AGENDA

The Planning and Zoning Commission and Board of Adjustment of the City of Sherman will hold a regular meeting Tuesday, August 22, 2017 at 5:00P.M. in the Council Chambers at 220 W. Mulberry to consider the following:

**Planning & Zoning Commission and Board of
Adjustments**

1 OVERALL SITE PLAN

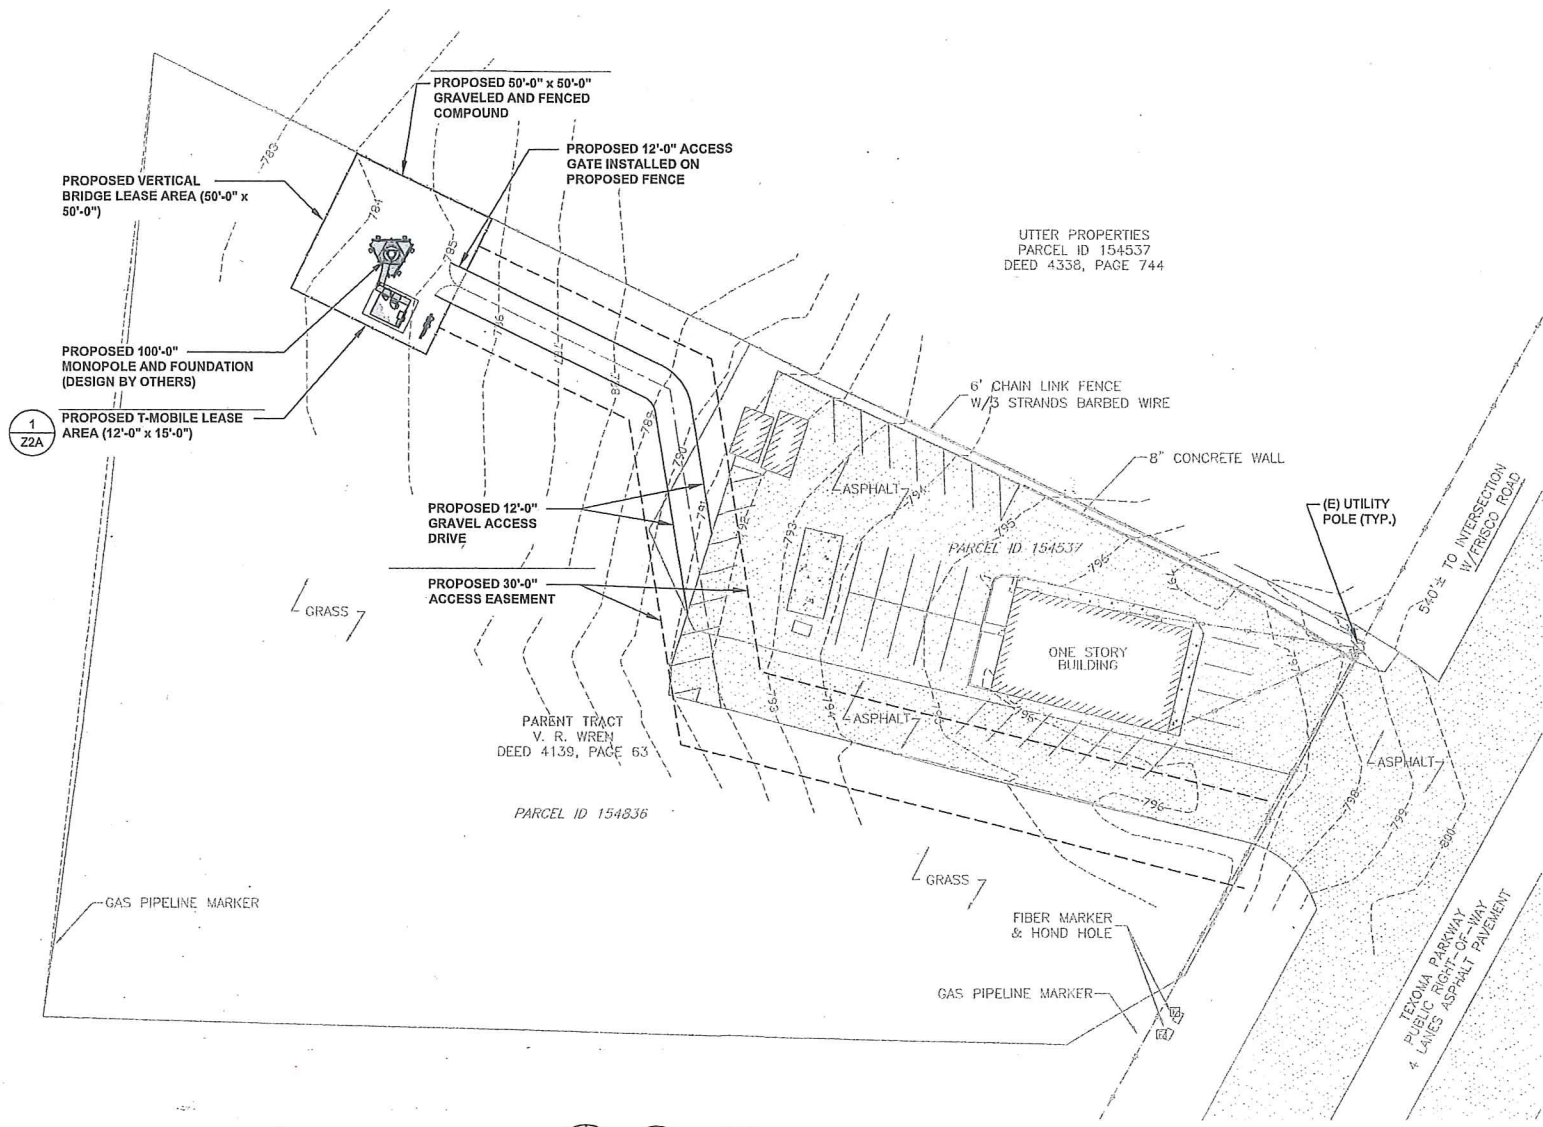
- Variance and site plan approval under Ordinance No. 2280, Section 7, Subsection (15)(v) to allow a 900' separation from another monopole telecommunications tower in lieu of the required 1,000 feet in an M-1 (Light Manufacturing) District.
- Variance and site plan approval under Ordinance No. 2280, Section 7, Subsection (15)(ii) to allow a 200' setback from a residential zone for a 100' telecommunications tower in lieu of the required 400 feet in an M-1 (Light Manufacturing) District.

10. Site plan approval is valid for a period of one year, if progress has not been made within that time period; resubmission to the Planning & Zoning Commission is required.

SITE/PARKING PLAN

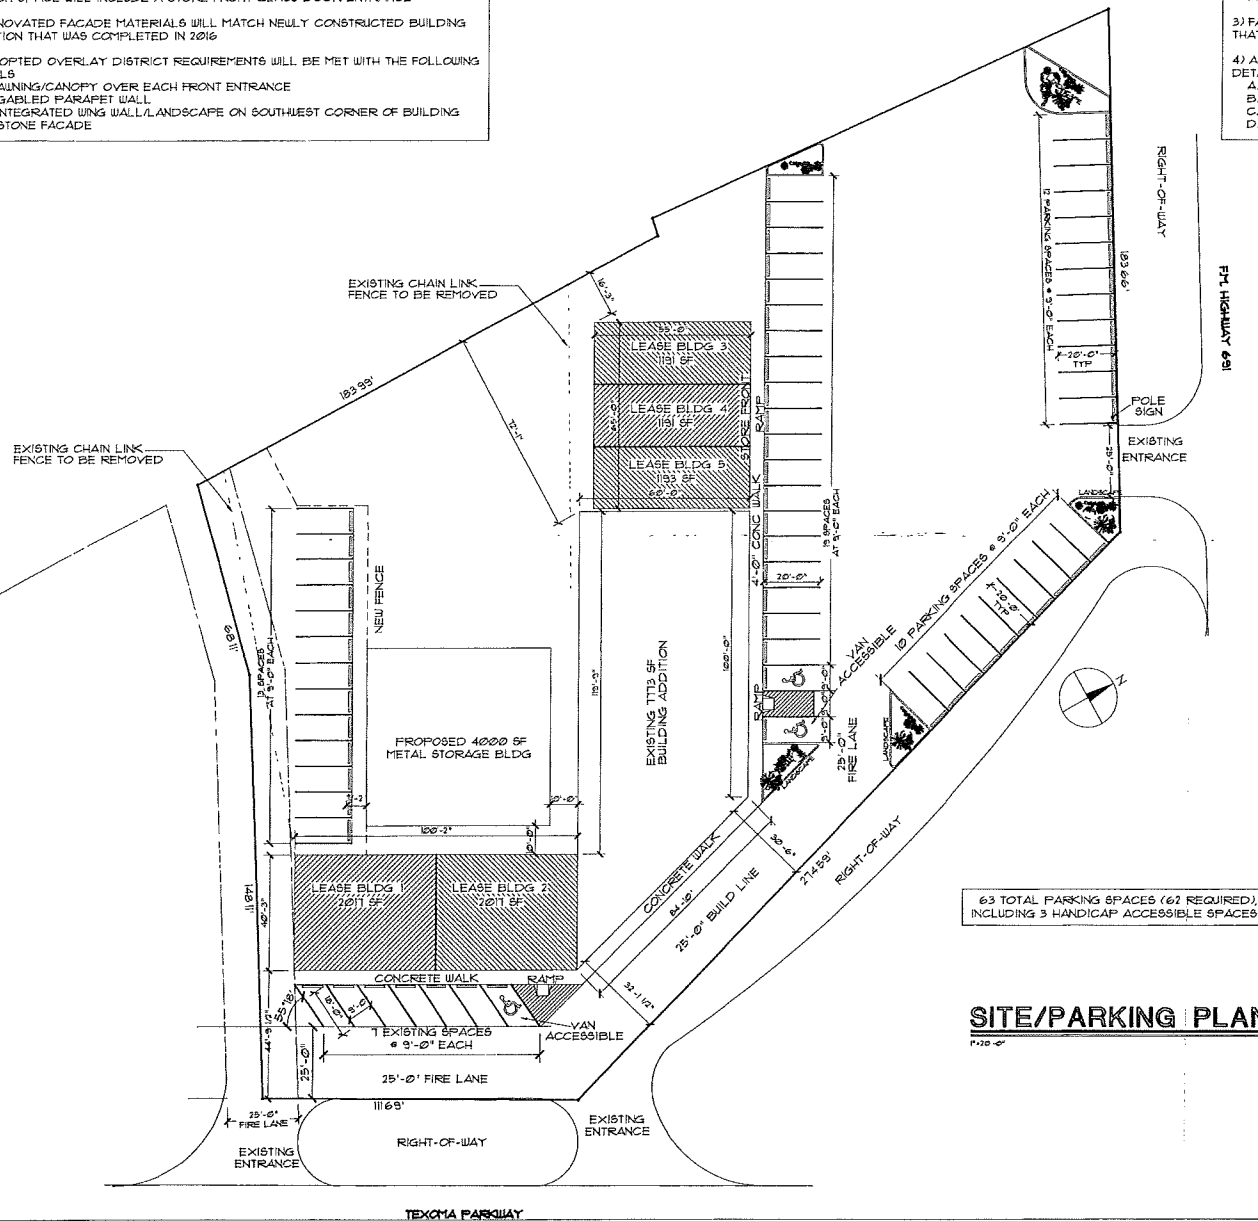
The owners are requesting site plan approval for a 4,000 square foot metal storage building and an addition to the existing building for lease spaces. They are requesting a variance to allow them to put metal siding on the proposed storage building in lieu of the required masonry facade. The building will be used for storage/warehouse with no retail use. They are also requesting exceptions for an 8' board on board fence behind the building and to not require a 10' irrigated and landscaped area along FM 691.

18. Internal water and sewer lines will be privately owned and maintained.
19. Verify right-of-way width at FM 691; additional right-of-way may be required.
20. The location of trash receptors must be approved by Public Works Department.
21. Entrances/Exits off of Texoma Parkway will be right-in, right-out only.

SITE PLAN

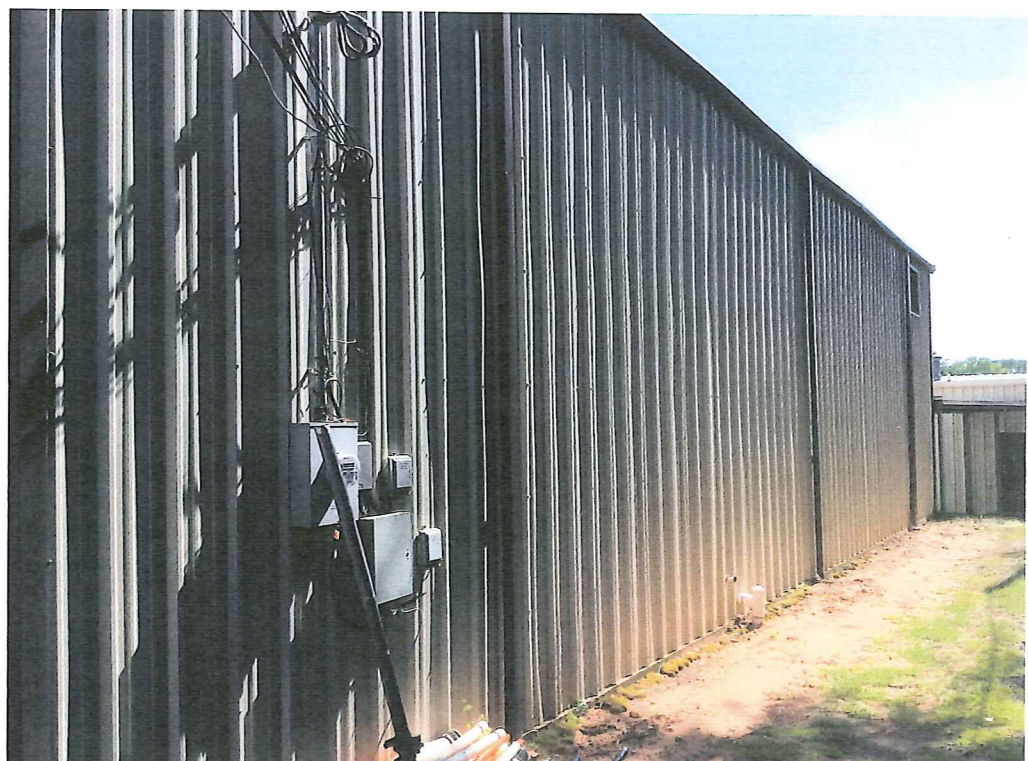
The property is located at 1518 South Austin Street between Olive and Staples Streets. The property is zoned a C-2 (General Commercial) District and also located in the O-1.2 (Sam Rayburn Overlay) District. The owners would like to change the zoning on the property to an R-1 (One Family Residential) District. There is an existing metal building located on the property and the owners plan to convert it to a residential dwelling.

1. All aspects of the R-1 (One Family Residential) District, the screening ordinance and the Residential Tree and Landscaping Ordinance must be followed.
2. Fire access, lanes and codes shall be coordinated with the Fire Marshal (903-892-7267).
3. Parking shall be provided for one space per bedroom, minimum two per unit; a parking space is considered to be 9'x20'.
4. All parking shall be on private property and shall not encroach into Austin Street right-of-way.
5. Review the zoning and development ordinance for additional requirements.
6. Site plan approval is valid for a period of one year, if progress has not been made within that time period; resubmission to the Planning & Zoning Commission is required.
